8.15. Sydney Harbour Bridge Cycling Infrastructure

PURPOSE:

This report analyses the two options for a *Bradfield Park Bike Ramp* currently being exhibited by Transport for New South Wales for community comment. It finds compelling reasons to reject these options in favour of the development of an *Eastern Harbour City: Sydney Harbour Bridge Access* project that addresses current cycling infrastructure design guidance and accommodates future cycling growth without impacting open space and heritage outcomes in North Sydney.

Figure 1: Missing links for inclusion in the Western Harbour Tunnel: Active Transport Network Review (E195)

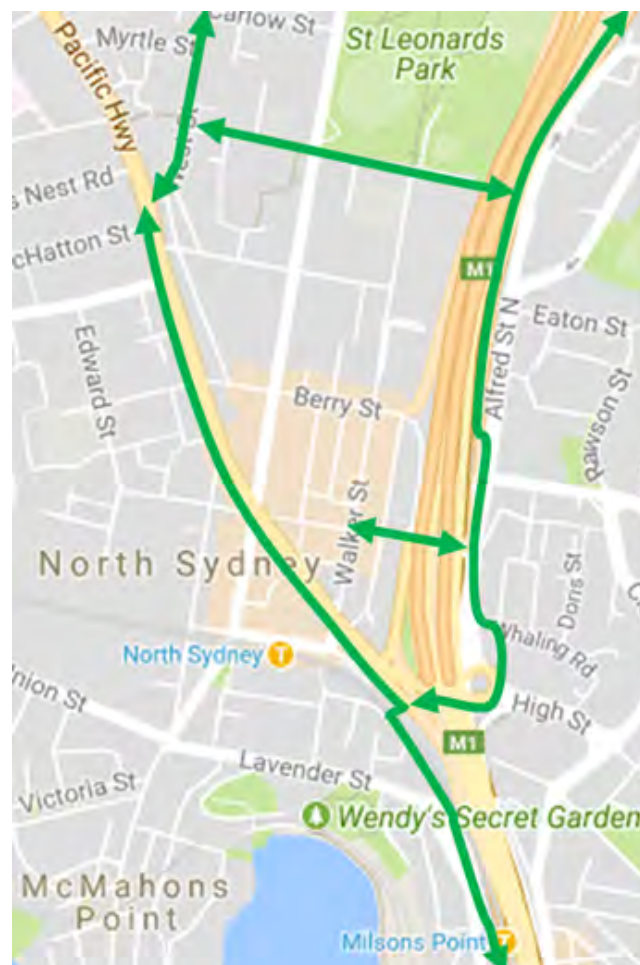
The *North Sydney CBD Transport Masterplan* identified a number of missing links in the North Sydney cycling network for inclusion and delivery as part of TfNSW’s *North Sydney Integrated Transport Program* and *Western Harbour Tunnel* projects (Figure 1). These missing links include:

- separated cycle lanes on the Pacific Highway, between the Middlemiss Street underpass and West Street,
- a pedestrian and cyclist shared path on the High Street overpass,
- a separated cycle lane on the Mount Street overpass, and
- a shared path on Alfred Street North (and the Kirribilli slip-lane) between High Street and Falcon Street.

Combined with Council's current Route 2 and Ridge Street cycling infrastructure, these new cycle links should form the basis for the Western Harbour Tunnel: Active Transport Network Review required by the Department of Planning as part of the Western Harbour Tunnel planning approval (conditions E195 and E195). The Western Harbour Tunnel planning approval also particularly notes the need to consider an active transport link on the Cahill Freeway, between High Street and Kirribilli as part of this review (condition E199).
